**PARTS & SERVICE
NEWS**

REF NO.	AT03114B
DATE	Jun. 21, 2004

SUBJECT: REPAIR PROCEDURES FOR WHITE SMOKE & BACK FIRE AT COLD OPERATION AND FOR TROUBLE MESSAGE 318 ON SAA6D170E-3

PURPOSE: To introduce modification procedure to repair the failures of white smoke exhaust out of the SAA6D170E-3 engines and back fire accompanied by the white smoke exhaust under low temperature environments by replacement of the air intake connector, presetting the engine controller program to match this modification and correcting frequent displays of the Error Code 318

Fig. 1

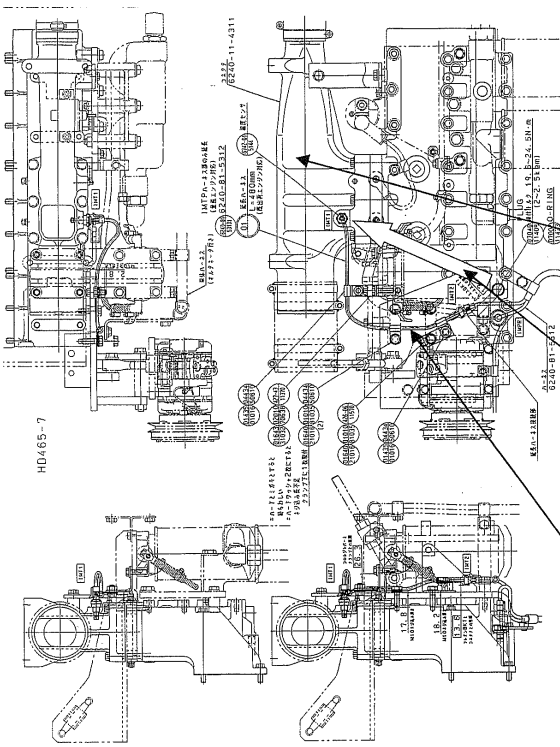
Addition and clamping of the extension harness

Replacement of the air intake connector
Replace the air intake connector with the new air intake connector equipped with the sensor mounting seat.

Shifting the position of the boost temperature sensor to the air intake connector where thermal influence of the head is smaller. In the meantime, install the plug to the opening after the intake air temperature sensor has been removed.

Fig. 2

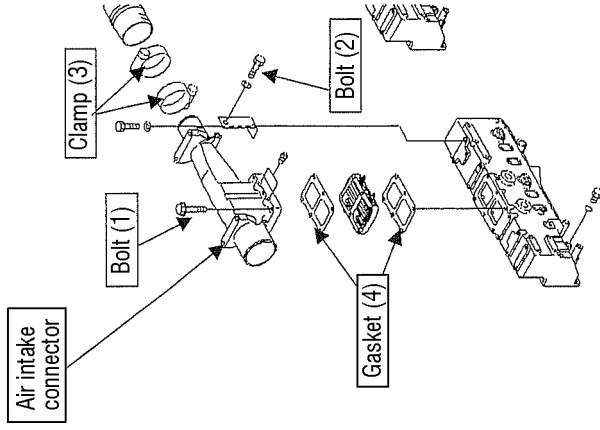
- 1) Remove the boost temperature sensor being installed to the lower section of the intake manifold.
Install the plug to the opening after the intake air temperature sensor has been removed.

Part No. of the plug:

Plug: 07040-11409

O-ring: 07002-11423

Tightening torque:

35 - 63 Nm (3.5 - 6.5 kgm)

Fig. 3

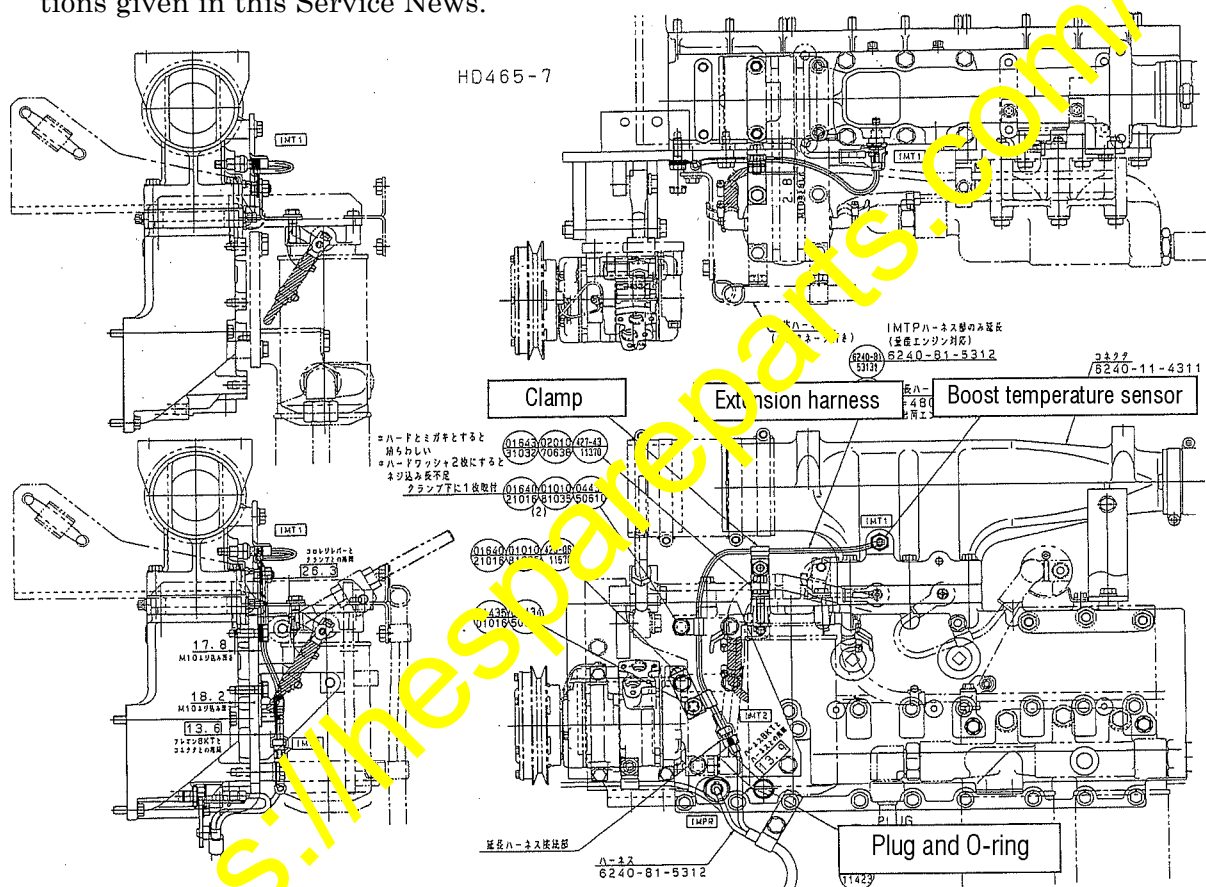
- 2) Install the removed boost temperature sensor to the replacing new air intake connector. Tightening torque: 12.6 - 14.2 Nm (1.29 - 1.45 kgm)
- 3) Connect the boost temperature sensor and the engine harness using the extension harness (6240-81-4930). Fix the extension harness using the clamps.

Since the clamping positions differ depending on the machine model, follow the instructions given in this Service News.

Photo. 4

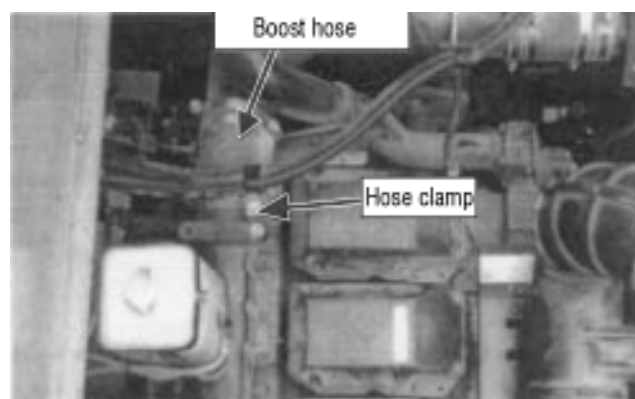
- 3) Connect the boost hose and clamp the machine harness and piping.

Fig. 5

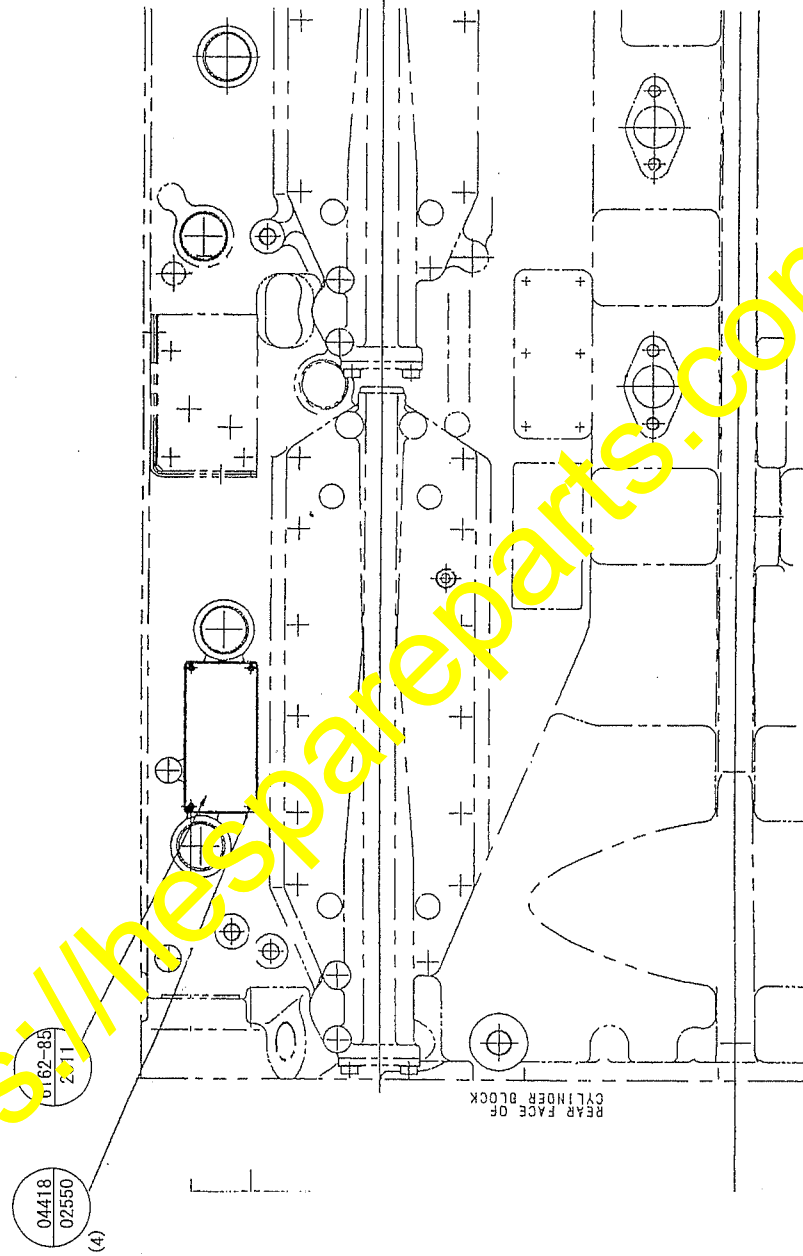
Replacing the engine nameplate on the HD465-7 and HD605-7

Remove the currently installed engine nameplate and attach the new nameplate.

※ Check that the serial number of the engine being indicated on the current engine nameplate and on the new engine nameplate are the same before installing the new engine nameplate.

Fig. 6

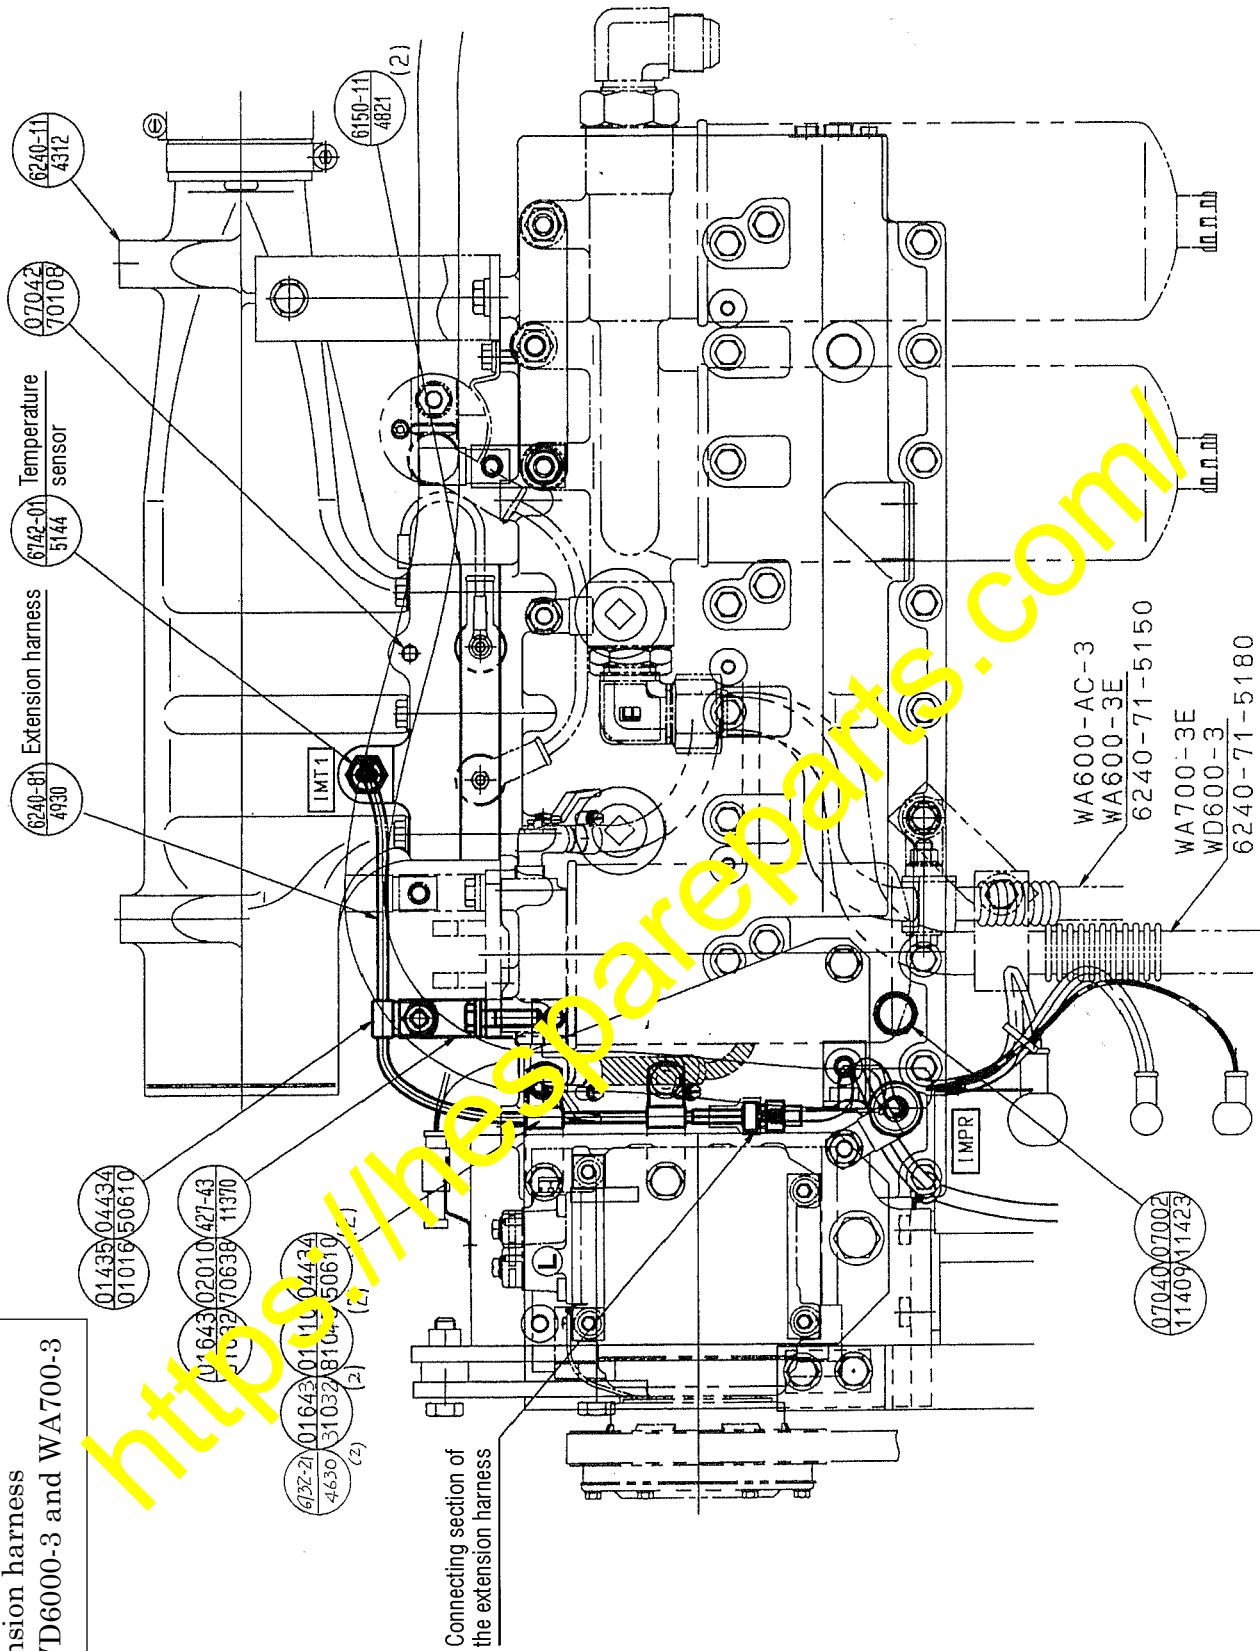
Clamping the extension harness
on the WA600-3, WD6000-3 and WA700-3

Fig. 7

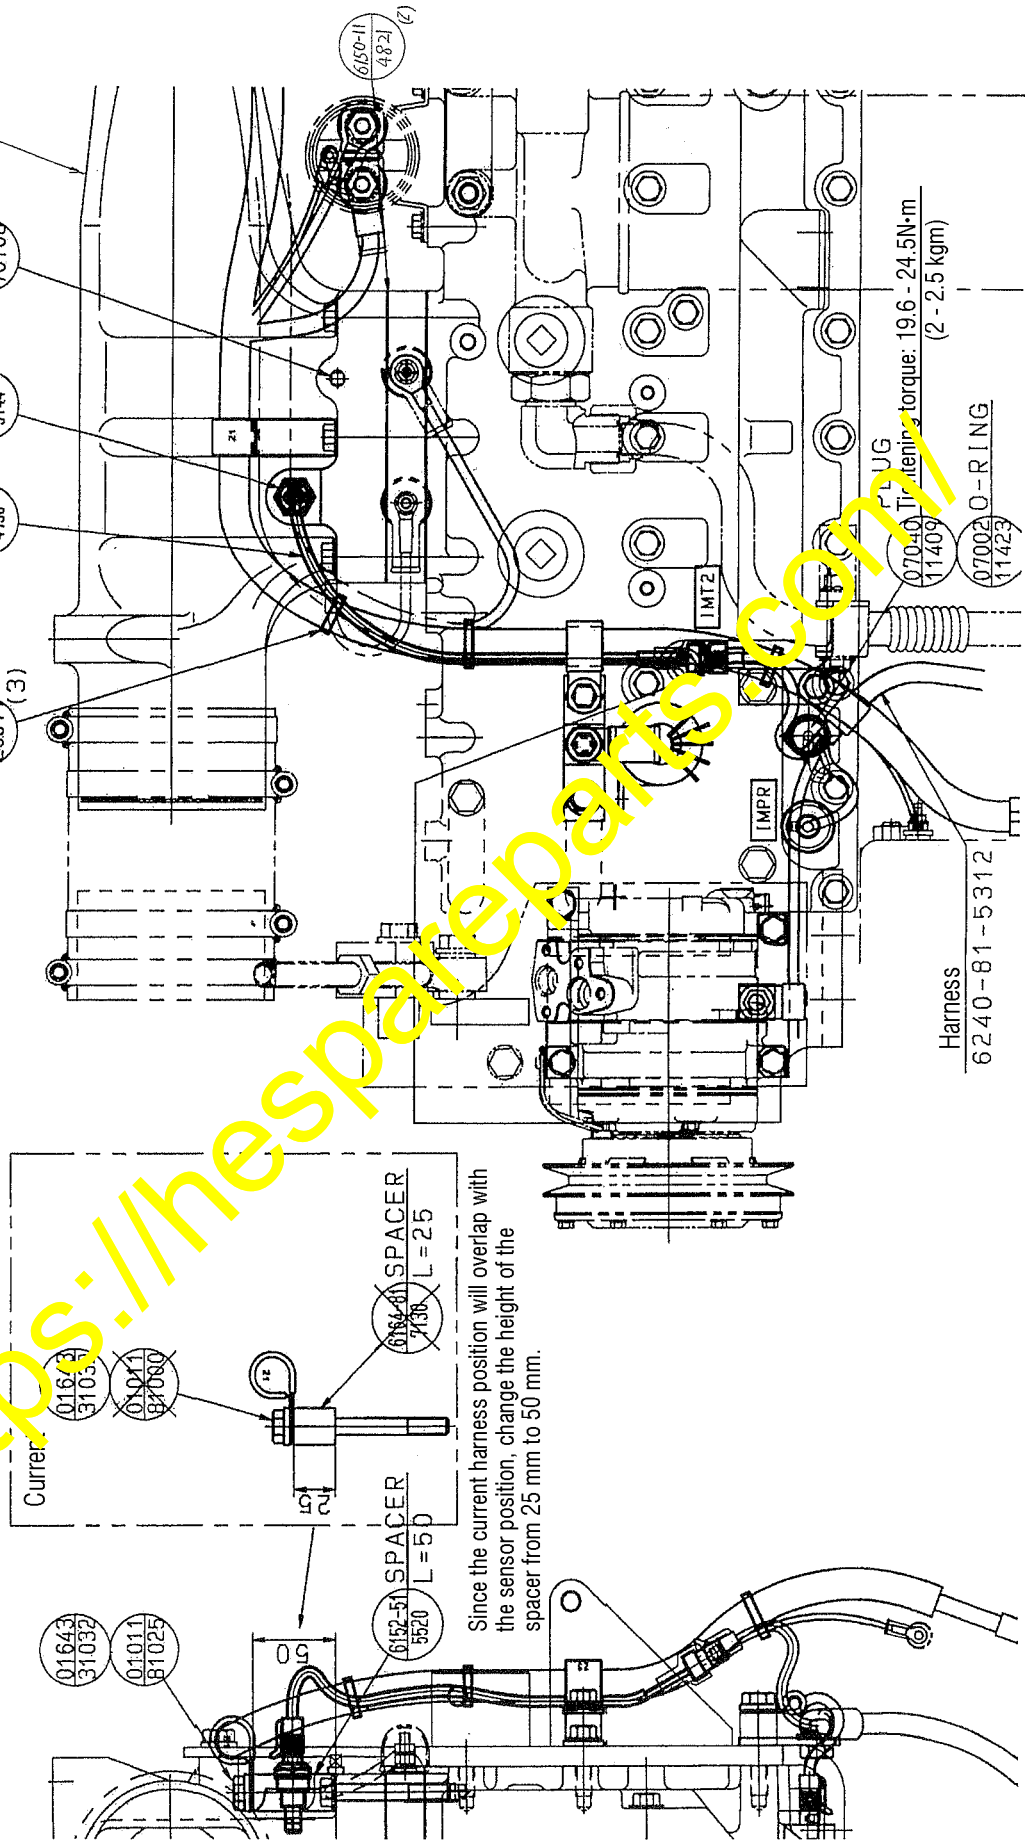
Clamping the extension harness on the PC1250-7
